PHILIPS *Service* notes

MODEL RF8

SUPPLEMENTARY SHEET

To be used in conjunction with Model RF8 service data sheet.

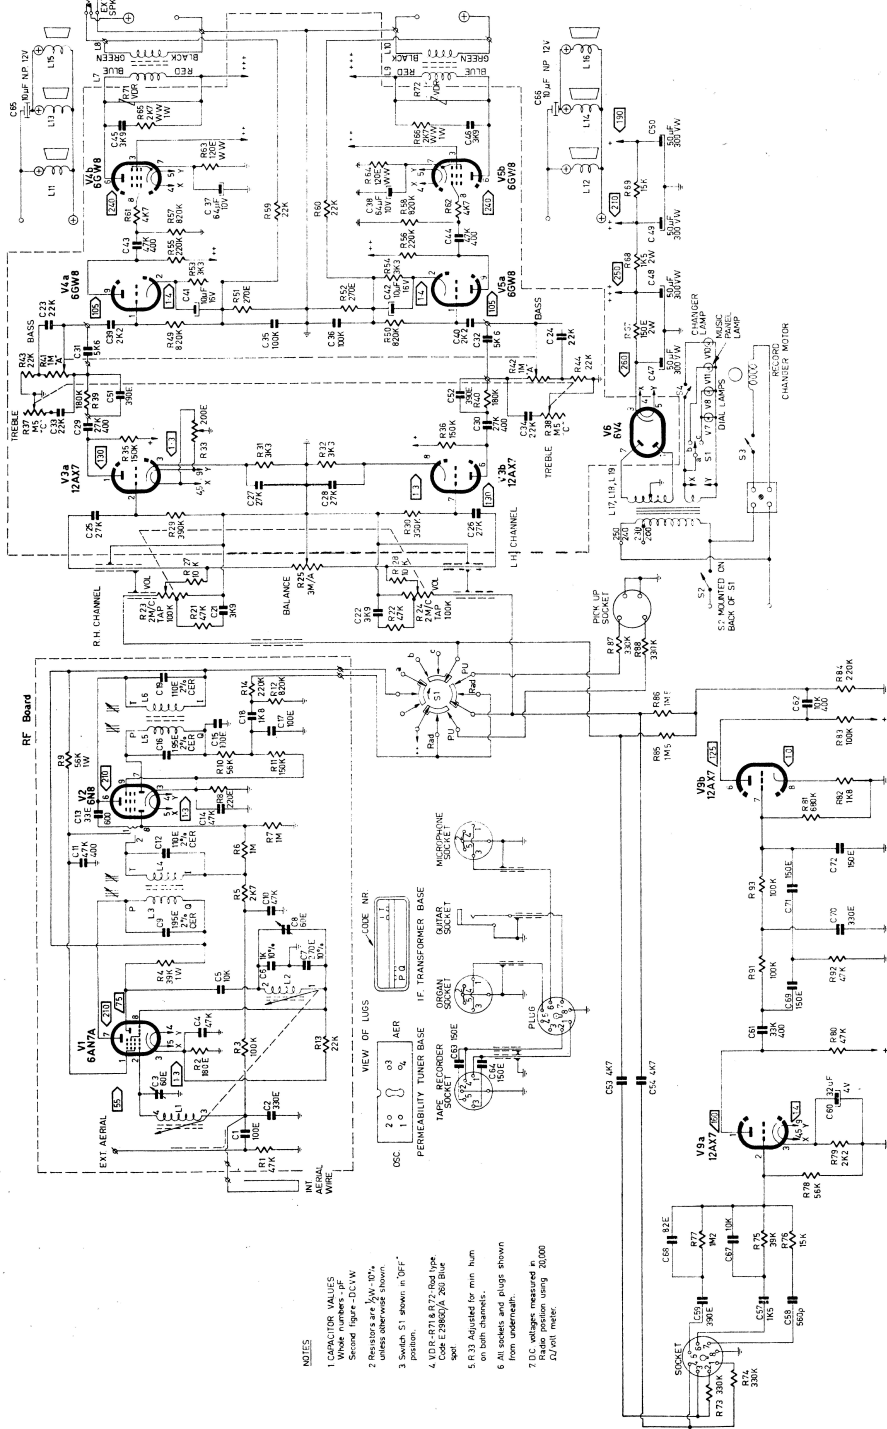
To increase bass response.

To avoid grid current in 6GW8 triode.

Found not to be necessary.

To modify high frequency response.

To correct frequency response after making high frequency response modification as above.

To simplify tape recorder connections.

To reduce hum.

C23 and C24 changed to 22K Polyester, 160V, 10 %
C.296.AA/A22K.

R53 and R54 changed to 3K3 carbon, $\frac{1}{2}$ W, 10 %, 1RC BTS
also note change in V4a/V5a cathode voltage to 1.4V.

C67 and C68 deleted (note new circuitry).

added—

R91—100K carbon, $\frac{1}{2}$ W, 10 %, 1RC BTS

R92—47K carbon, $\frac{1}{2}$ W, 10 %, 1RC BTS

R93—100K carbon, $\frac{1}{2}$ W, 10 %, 1RC BTS

C69—150E ceramic, 500V, 10 %, C.304.GB/A150E

C70—330E ceramic, 500V, 10 %, C.304.GH/A330E

C71—150E ceramic, 500V, 10 %, C.304.GB/A150E

C72—150E ceramic, 500V, 10 %, C.322.BC/P150E
value changed—

R81 changed to 680K, carbon, $\frac{1}{2}$ W, 10 %, 1RC BTS.

R75 changed to 39K carbon, $\frac{1}{2}$ W, 10 %, 1RC BTS

R76 changed to 15K carbon, $\frac{1}{2}$ W, 10 %, 1RC BTS

R77 changed to 1M2 carbon, $\frac{1}{2}$ W, 10 %, 1RC BTS

R78 changed to 56K carbon, $\frac{1}{2}$ W, 10 %, 1RC BTS

C57 changed to 1K5 Polyester, 400V, 10 %, C.296.AC/A1K5

C58 changed to 560E Styroseal, 630V, 10 %, Ducon DFB
added—

C67—10K Polyester, 400V, 10 %, C.296.AC/A10K.

C68—82E ceramic, 500V, 10 %, C.304.GB/A82E.

C53 and C54 changed to 4K7 Polyester, 400V, 10 %, (also changed position).
C.296.AC/A4K7

C63 and C64 changed to 150E ceramic, 500V, 20 %, (also changed position).
C.322.BC/P150E

R89 and R90 deleted.

R73 and R74 changed position.

C62 changed to 10K Polyester, 400V, 10 %, C.296.AC/A10K.
